Planned Change Request

**Waste Isolation Pilot Plant
Repository Reconfiguration**

**DOE/CBFO 11-3478
Revision 0**

**United States Department of Energy
Waste Isolation Pilot Plant**

Figure 2. Plan view of the revised repository layout

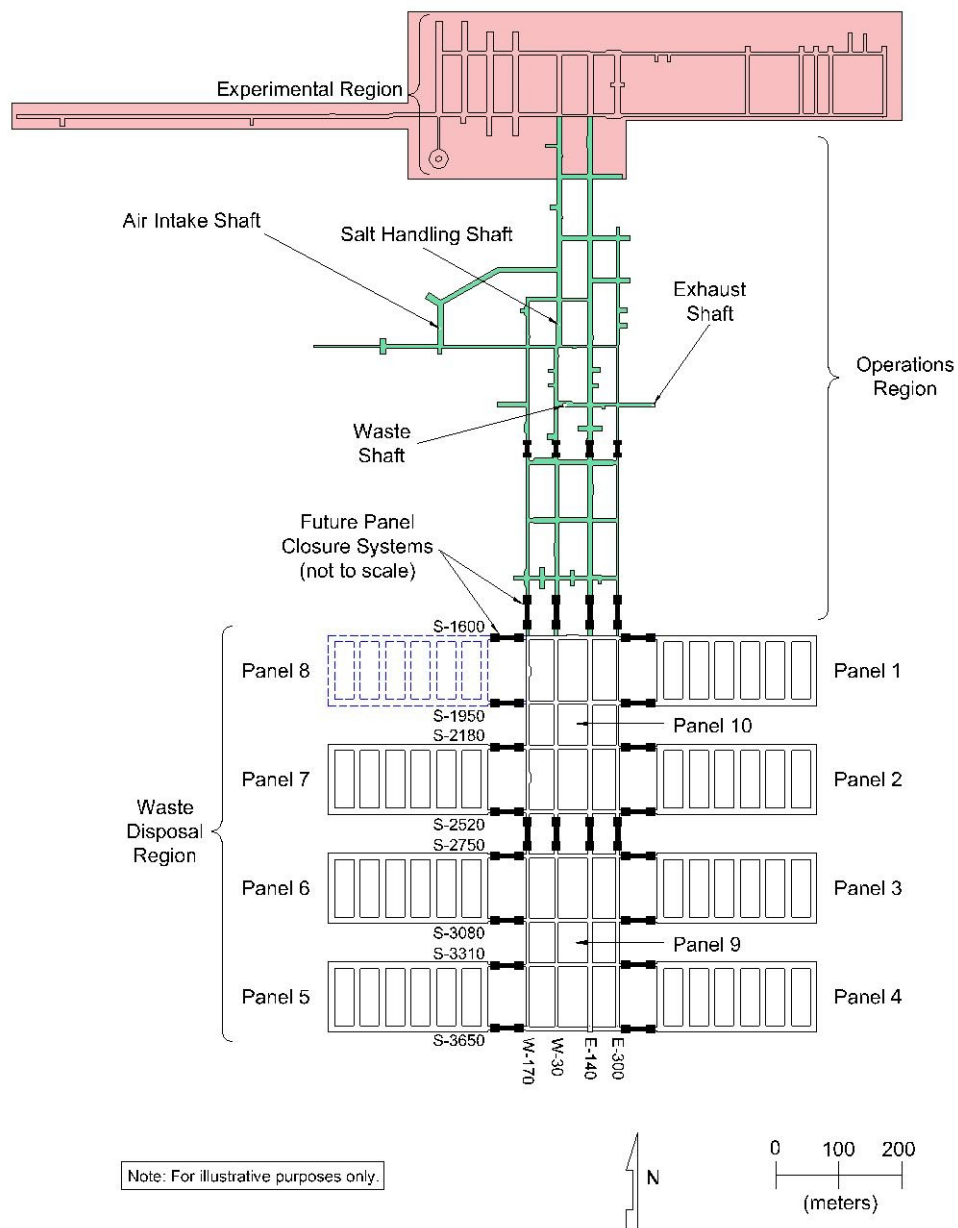
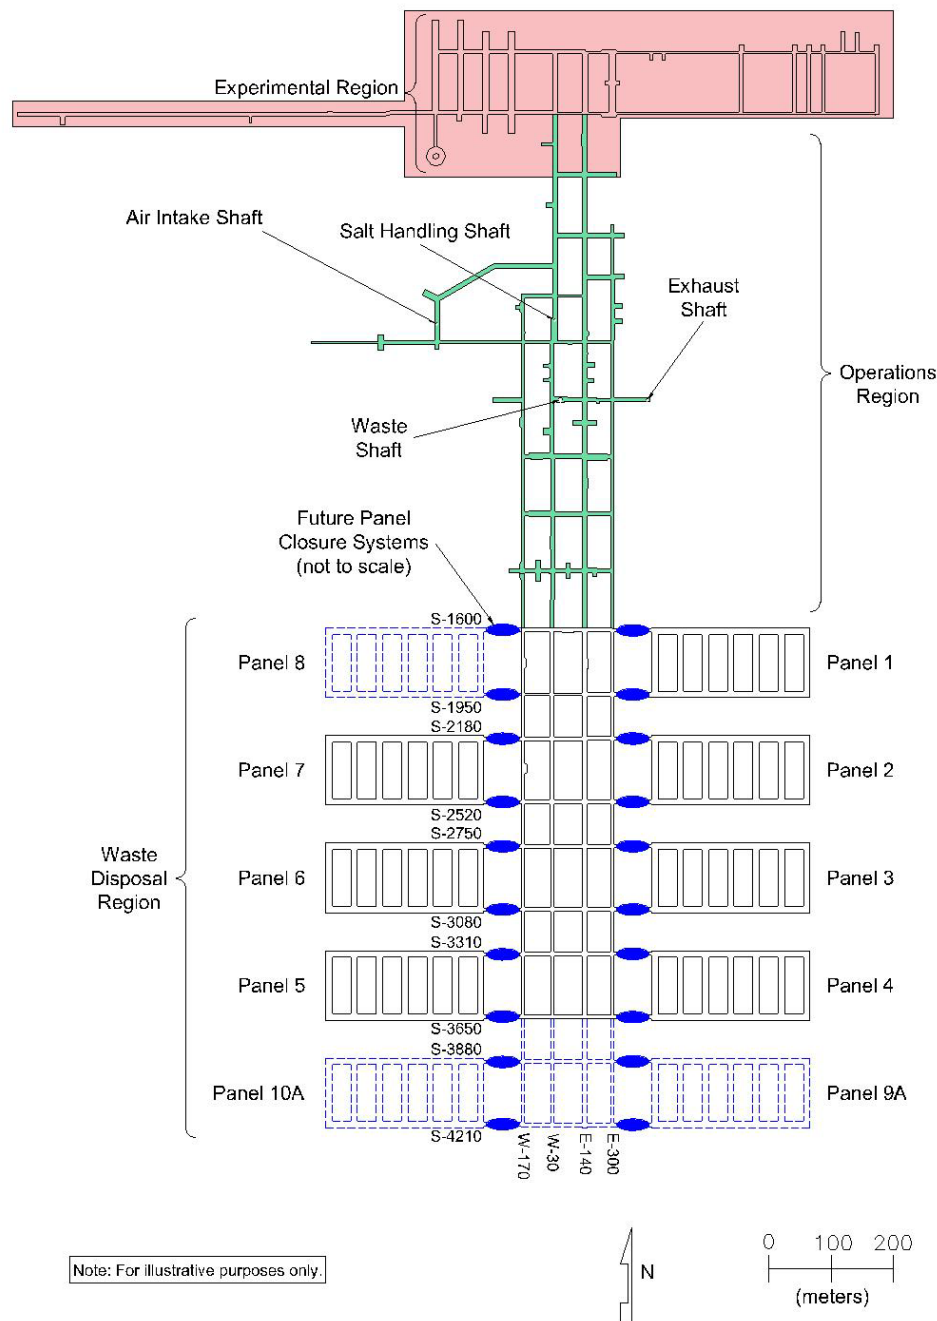
The U.S. Department of Energy (DOE) is proposing a change to the configuration of the repository at the Waste Isolation Pilot Plant (WIPP). The proposed configuration will relocate Panels 9 and 10 from the main north-south access drifts to south of the existing Panels 4 and 5. The DOE requests this change based on the following observations:

- Convergence rates in the Panel 9 and Panel 10 access drifts W-30 and E-140, in the southernmost part of the main north-south access drifts, are observed to be 1.5 to 5 inches per year (in/yr). These high convergence rates are caused by two factors: (1) the main access drifts have been open for 6 to 30 years and, as the result, the salt has become extensively fractured at some locations; and (2) the excavations for Panels 3, 4, 5, and 6 are directly adjacent to Panel 9, resulting in a higher local extraction ratio that increases the convergence rates in the main north-south access drifts.

- The main north-south access drifts must be widened to 33 feet (ft) in order to provide clearance for remote-handled transuranic (RH TRU) waste containers that are emplaced in the walls of the drifts. This widening will significantly change the cross-section of the main north-south access drifts, which are currently 15 to 25 ft wide.

- Widening the access drifts has shown an increase in convergence rates as high as 367%, based on observations from a drift that was widened within the footprint for Panel 10.

- The resulting increase in convergence rates and local fracturing in the widened drifts represents a concern for worker safety and will require more intensive maintenance involving roof bolts and chain link fencing and possibly more aggressive ground support measures, such as steel sets.

In summary, relocating Panels 9 and 10 to south of the existing Panels 4 and 5 will enhance worker safety and reduce maintenance requirements by providing a more stable geotechnical environment for the last two waste emplacement panels in the repository.

After years of mining and waste disposal activities, geotechnical issues in the main access drifts and cross drifts have been identified. Portions of these access drifts which were initially mined six to 30 years ago. The ongoing ground movements are controlled and safe access is ensured through continuing maintenance. However, given the age of the main access drifts and the need to widen these drifts for emplacement of RH TRU waste, any additional excavation to enlarge these entries for waste disposal will cause an increase in ground movements that must be controlled. As a result, the DOE has evaluated the relocation of the waste destined for disposal in Panels 9 and 10 to an alternate location in the underground facility south of the existing Panels 4 and 5. Figure 2 shows the proposed reconfiguration, with 10 panels for waste emplacement and a central region without waste.

As the repository ages, the condition of the host rock locally around the excavations degrades. Ground support systems need to be installed and additional mining and scaling performed to maintain safe access. If the south access drifts are enlarged for disposal of CH TRU and RH TRU waste, the response to the removal of pillar volume and to the increase in roof span will be an increase in convergence rates by a factor of 3.6 or more, based on *in situ* observations. In another example that demonstrates the response to enlarging an access drift, Figure 4 shows the convergence rates for an access drift that was widened from 16 ft to 20 ft. The measurements were taken in an area located within the footprint for Panel 10, near the intersection of W-30 and S-2067. Figure 4 demonstrates that the vertical convergence rate increases from less than 1 in/yr before widening to approximately 3.5 in/yr after widening. Given these observed geotechnical responses, DOE recommends that the main north-south access drifts should not be enlarged, and that Panels 9 and 10 should be relocated to south of Panels 4 and 5 (i.e., south of S-3650), as shown in Figure 2.

Figure 3 Convergence rate increase at W-30, S-2275 after drift was widened

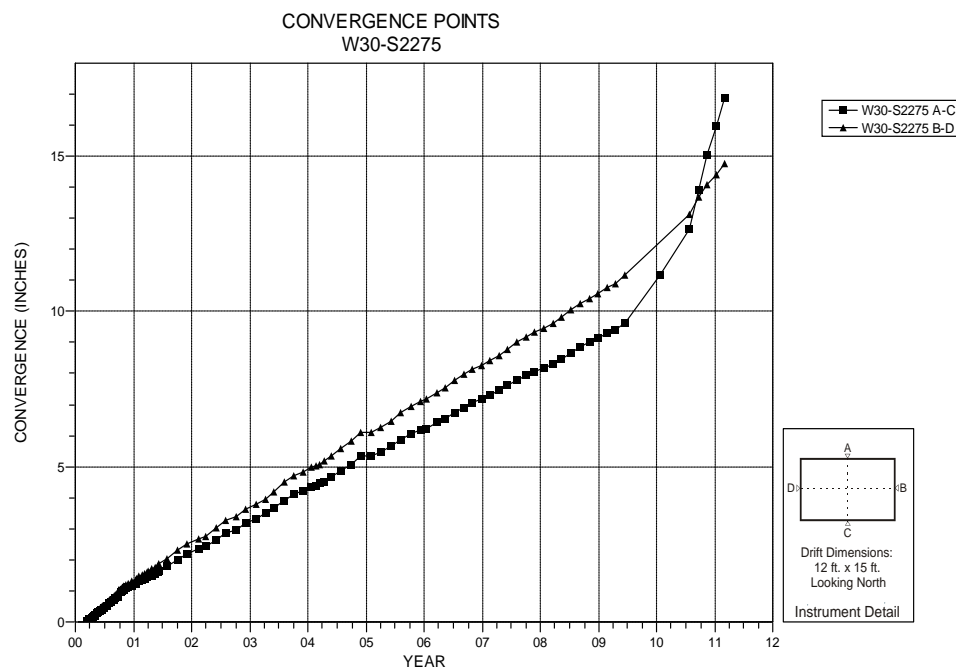
The W-30 drift was initially mined to 13 ft high by 16 ft wide between February 1986 and December 2000. Additional mining completed in July 2010 enlarged this section to 15 ft high by 20 ft wide. After the final excavation, the convergence rates in W-30 Panel 9

Figure 4. Comparison of vertical and horizontal convergence rates before and after widening the access drift near W-30 and S-2067 (within footprint of Panel 10)

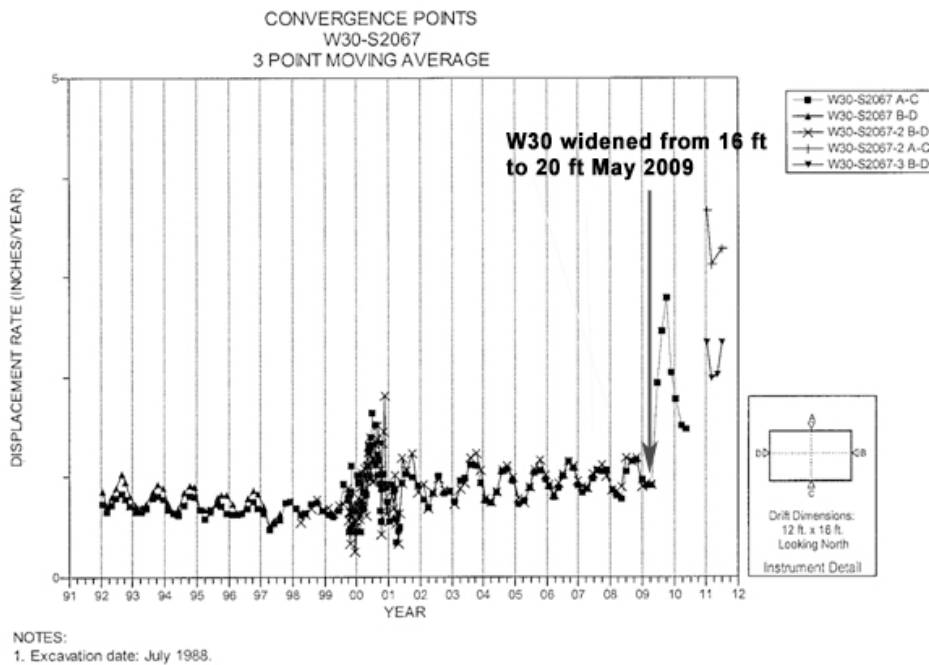
From late 2001 through early 2005, the E-140 drift was enlarged to 14 ft high by 25 ft wide and convergence rates in this area range from 2.5 to almost 5.5 in/yr as indicated in Table 2. Table 2 shows the average convergence rates (inches per year) from measurements taken from mid 2009 to mid 2010. (DOE 2011). The convergence in this area is to due to a combination of both widening and anhydrite stringers (geological features in this area of the repository) that have caused the roof beam to separate. Additional roof bolting has been done in this area to maintain safe conditions. Widening the access drifts in this area will further increase the convergence rates in Panel 9.

Figure 5 Overall mean CCDFs for total normalized releases for the PC3R PA and for PABC-2009

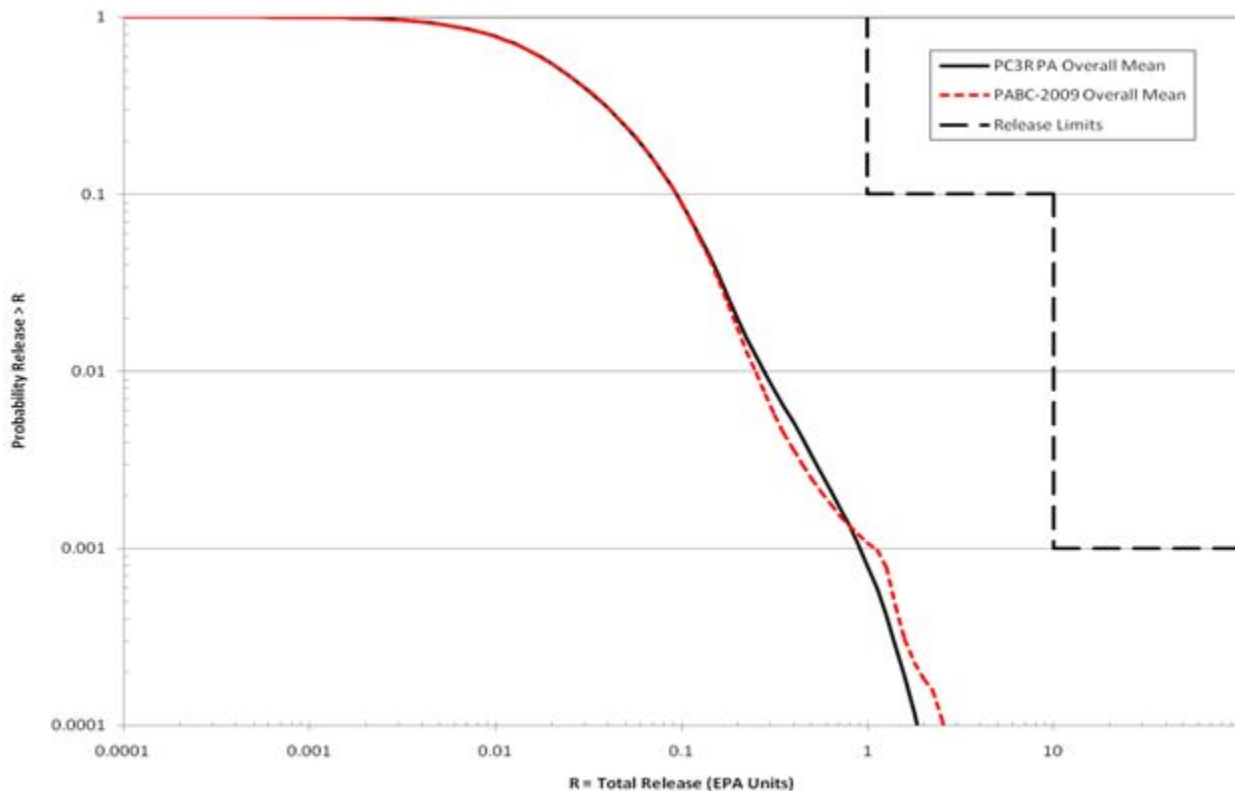
revised panel closure design with an open central area will produce small differences from the PABC-2009, as shown in Figure 5. The primary cause of these small differences is the time required for the run-of-mine salt to reconsolidate combined with the open central area, resulting in reduced repository pressure in the waste emplacement panels (Camphouse et al. 2011).

Figure 5 presents the predicted total mean normalized releases for the PC3R PA and the PABC-2009. The results in Figure 5 demonstrate that the differences in predicted total mean normalized releases for the PC3R PA and PABC-2009 are relatively minor throughout the probability range of 0.001 to 1 and essentially equal for probabilities between 0.01 and 1. The numerical values in Table 3 (Camphouse et al. 2011, Table 11) also demonstrate that the statistics for the distribution of complementary cumulative distribution functions (CCDFs) about the mean are similar for the PC3R PA and for the PABC-2009. It follows that the mean values and the distributions of total normalized releases for the combined changes from repository reconfiguration and panel closure redesign are very similar to the corresponding parameters for the PABC-2009. In addition, the mean total normalized release from the PC3R PA is 0.89 at a probability of 0.001 (see Table 3), and therefore the potential releases for the PC3R are less than those calculated for the PABC-2009.
